From: Charlotte Burrows on behalf of Planning.Responses
Sent: 14 September 2017 13:44
To: Planning Scanning
Subject: FW: FG/108/17/DOC - Condition 4 Internal Noise levels - Ferring
Attachments: JSL2159_101B.pdf

Land at Ferring
Worthing

Site Boundary Plan

101
B

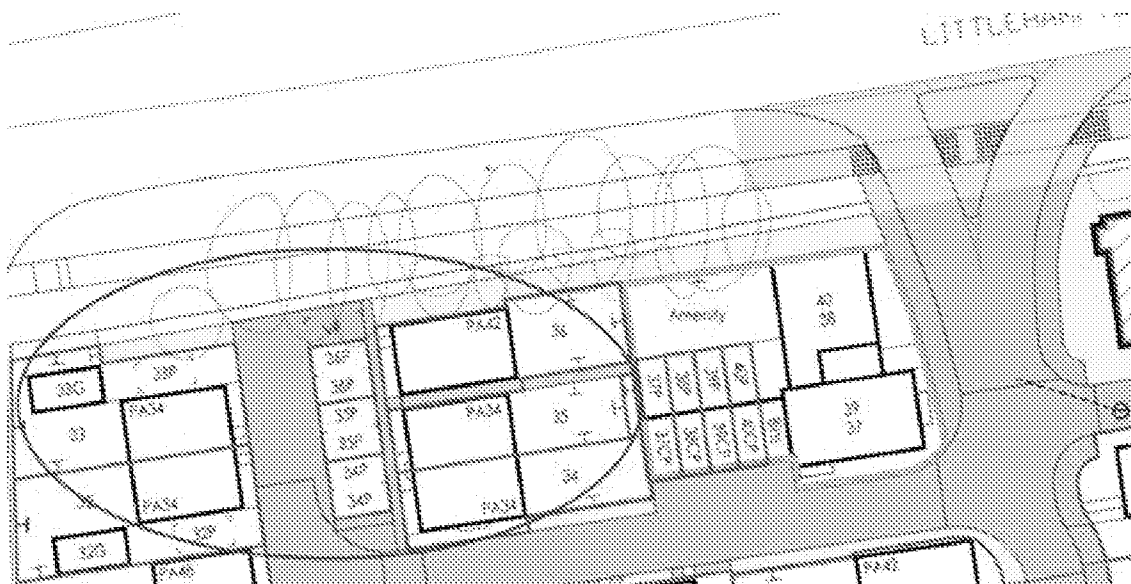
My question was regarding the remaining units which as you will see in the below image have only plot 36 adjacent to the a259 with 35 and 34 protected by 36.

We intend on carrying out the testing in 2 weeks time so to avoid any disruption I wanted to check if this was an error and instead the condition should state 33 and 36 or if you would like me to carry out testing to the 3 units listed in the condition?

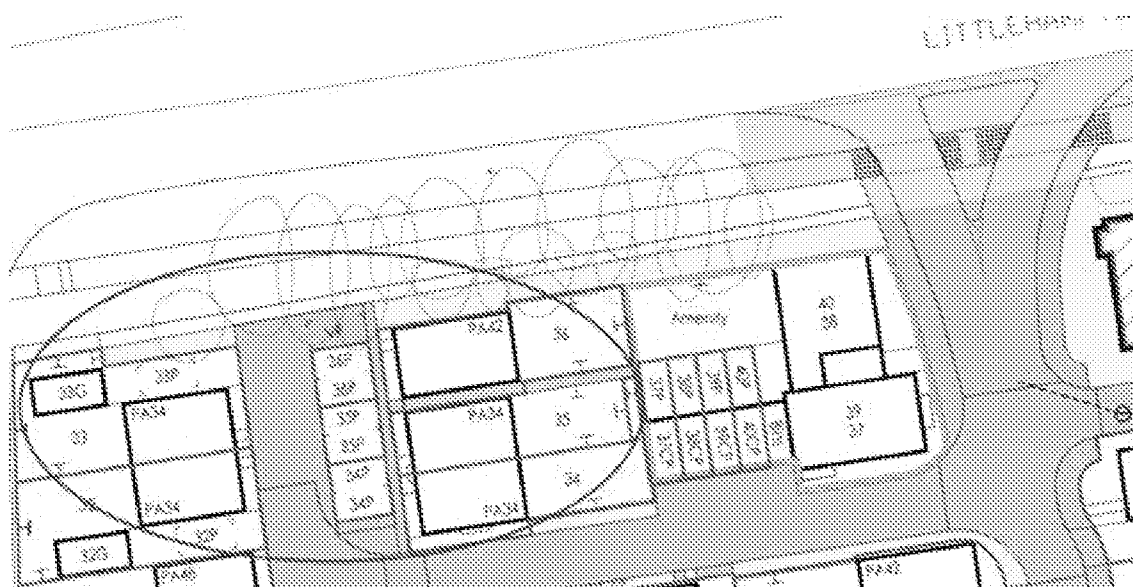
Going forward we still are due to test more plots alongside the A259. The condition does ask for testing of 3 plots (34-36) however only one of those plots front on to the A259 and we intend on testing the two left on site that do (33 and 36). Please see the exert of the site below for reference.

Can you please confirm that you would like Taylor Wimpey to test plots 33 and 36 instead of what is stated in the condition as 34-36 that contains two units that are shielded by plot 36 or if you would like us to test all 3 units as stated?
